2. ACTION ITEM: Recommendation to review and recommend approval to the City Council the Cedars Townhomes Preliminary Plat application, as conditioned, and adopt the Findings of Fact, Conclusions of Law, and Decision.

3. ACTION ITEM: Recommendation to review and approve the 450 Wood River Drive Residence Floodplain Development Permit application, as conditioned, and direct staff to return with the findings of fact.

**STAFF REPORT  
KETCHUM PLANNING & ZONING COMMISSION  
REGULAR MEETING OF MAY 28, 2024**

**STAFF REPORT**  
**KETCHUM PLANNING AND ZONING COMMISSION**  
**MAY 28, 2024 MEETING**

DRAWING NUMBER:  
**A-400**

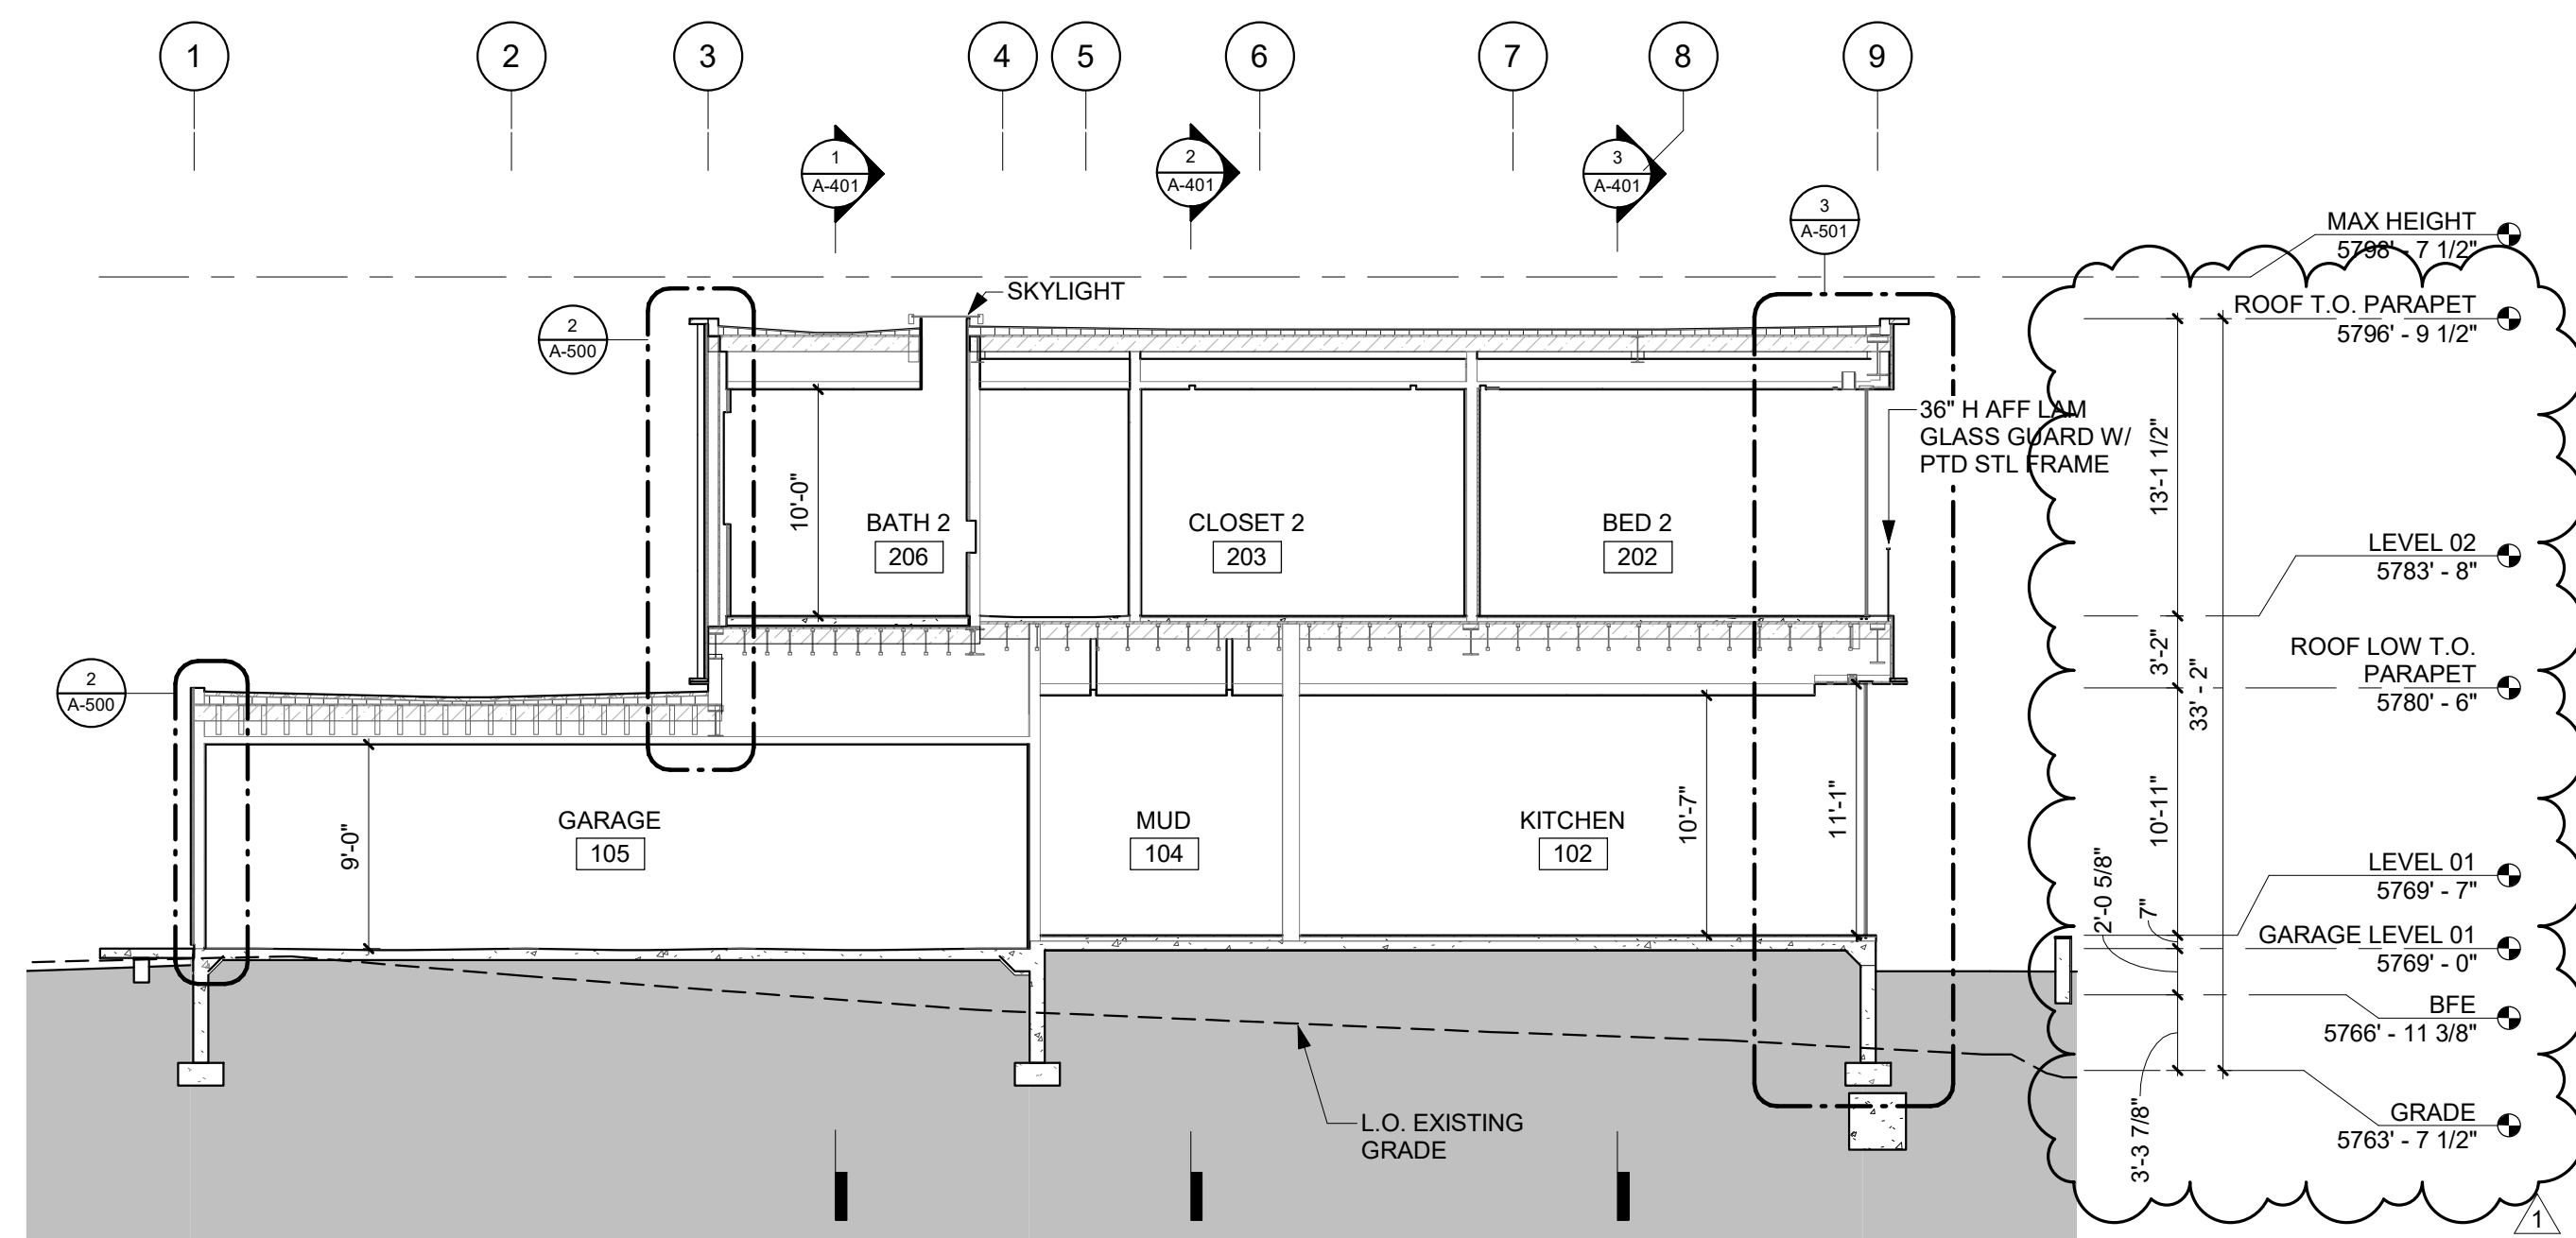
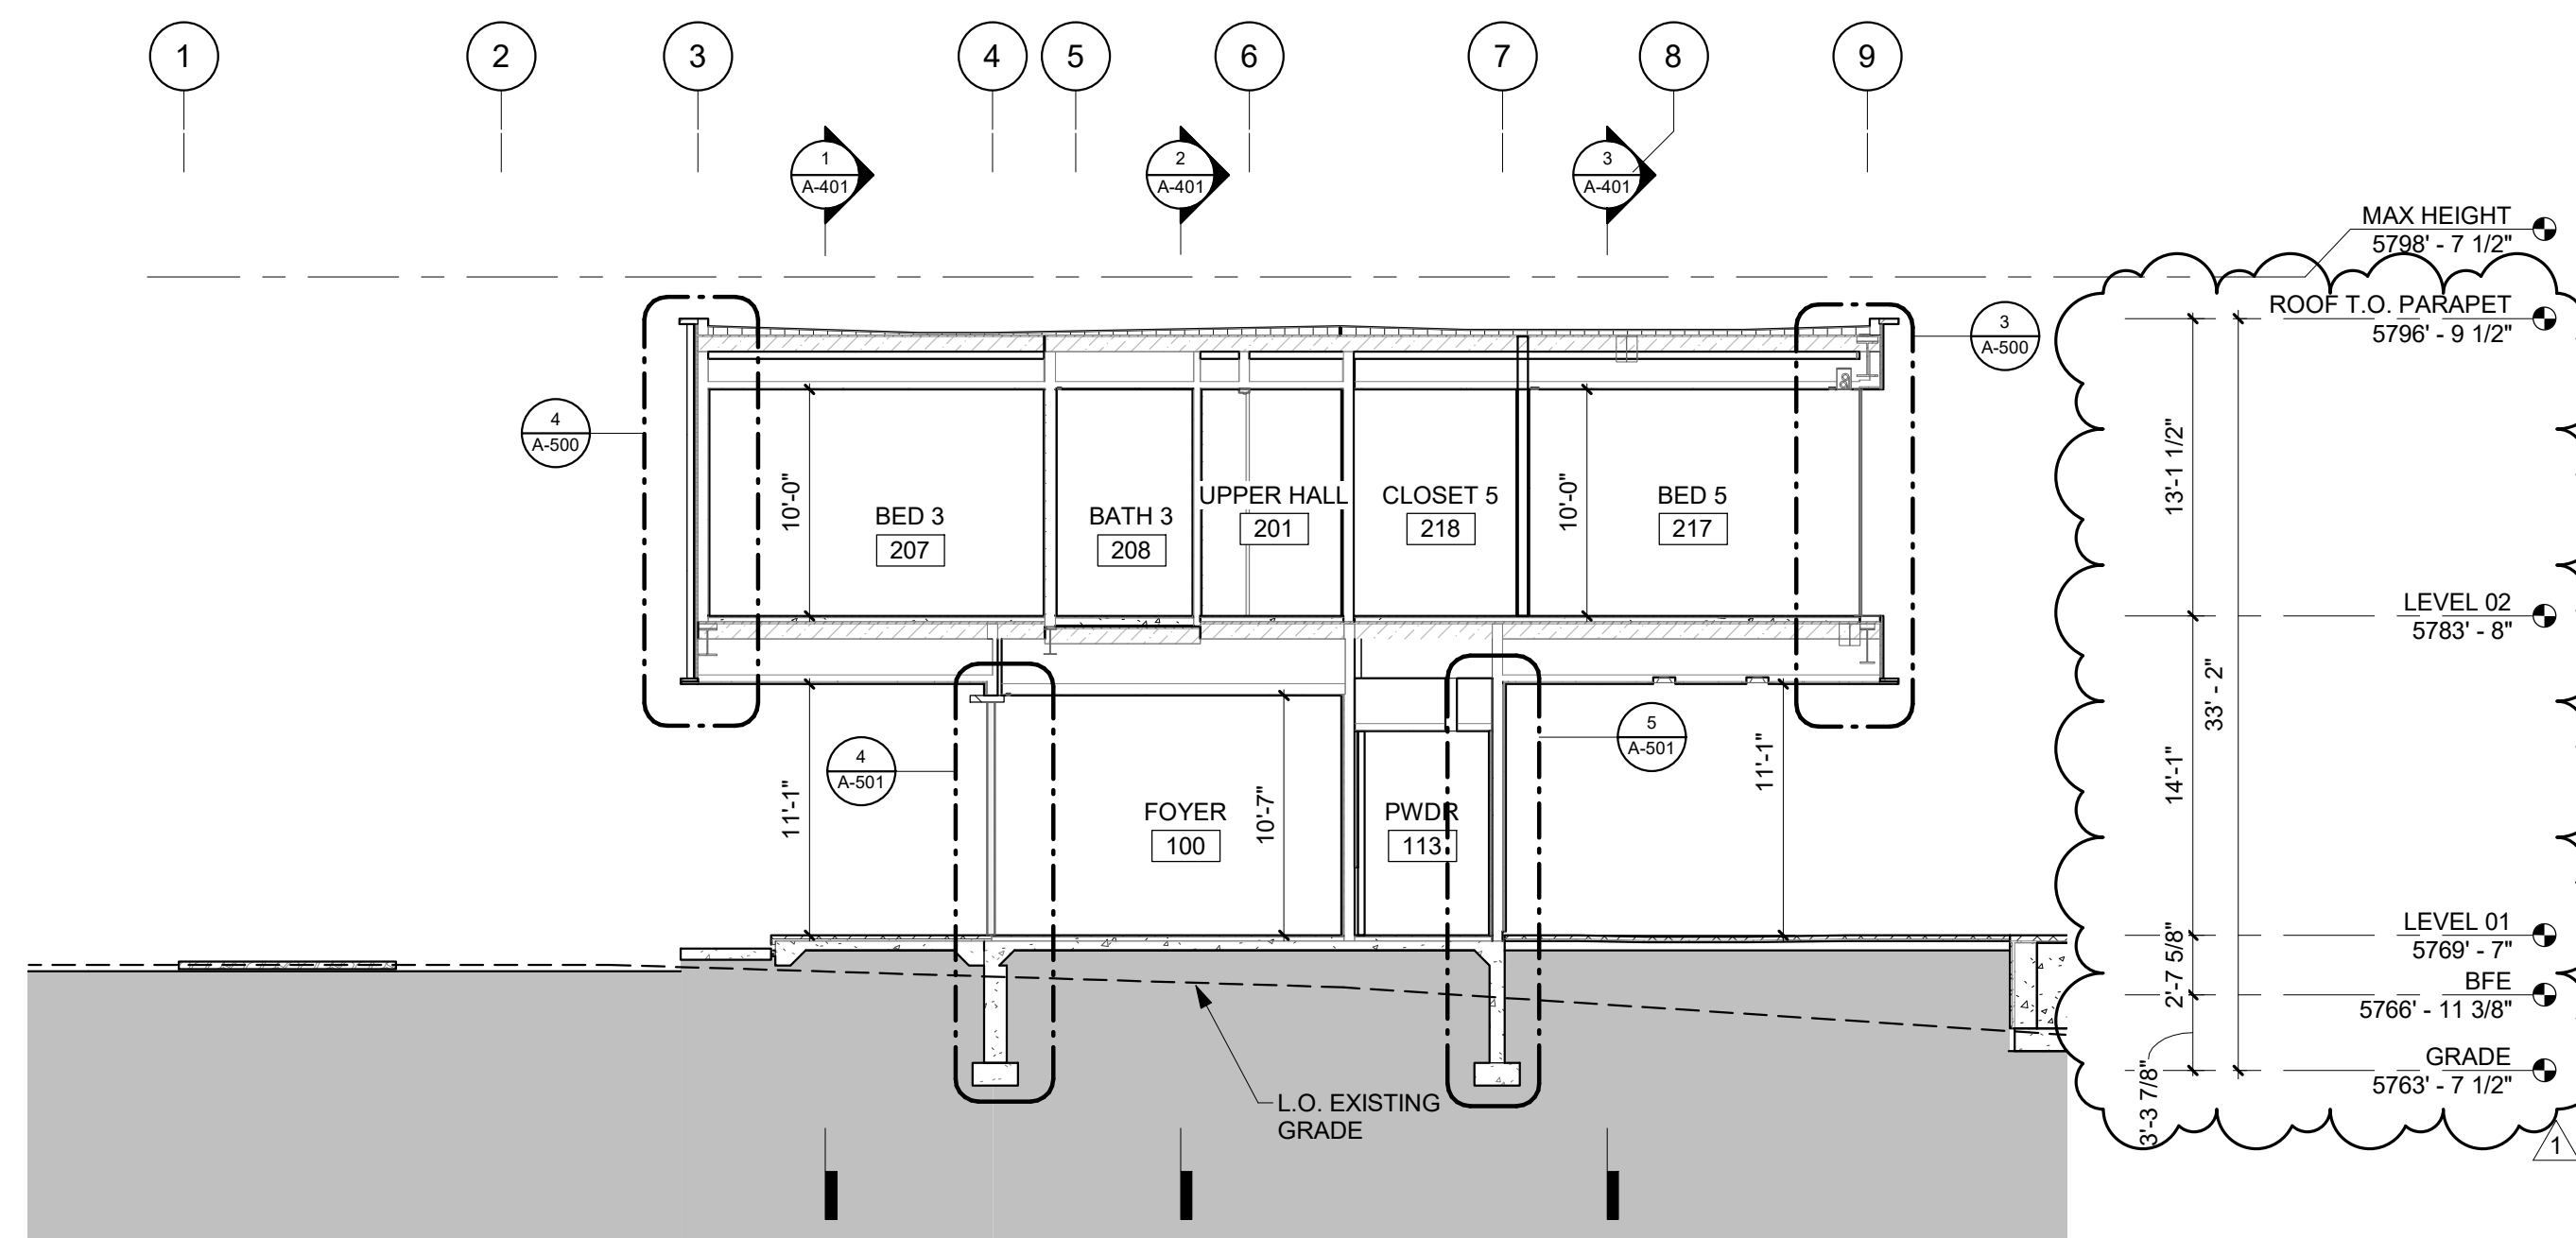
<i>Staff Comments</i>	<i>The top of the lowest floor (finished floor) is elevated 24" above the Base Flood Elevation of 5766.95 as shown on Sheets A-400 &amp; A-401. As the proposed elevation is located within the AE zone the top of the lowest floor is required to be 24" above the BFE.</i>
<input checked="" type="checkbox"/>	<input type="checkbox"/>	<input type="checkbox"/>	17.88.050(E)10	<p>The backfill used around the foundation in the SFHA floodplain shall provide a reasonable transition to existing grade but shall not be used to fill the parcel to any greater extent.</p> <p>a. Compensatory storage shall be required for any fill placed within the floodplain.</p> <p>b. A CLOMR-F shall be obtained prior to placement of any additional fill in the floodplain.</p>
			<i>Staff Comments</i>	<i>Backfill used around the foundation which provides a reasonable transition to existing grade is not considered as part of the compensatory storage requirement. The proposed cut on the site is 638.1 cubic yards while the proposed fill not associated with the residence is 265.4 cubic yards, resulting in a net cut-fill balance of 372.7 cubic yards. The proposed cut occurs around modified drainage channels and wetlands which are hydraulically connected to the Big Wood River.</i>
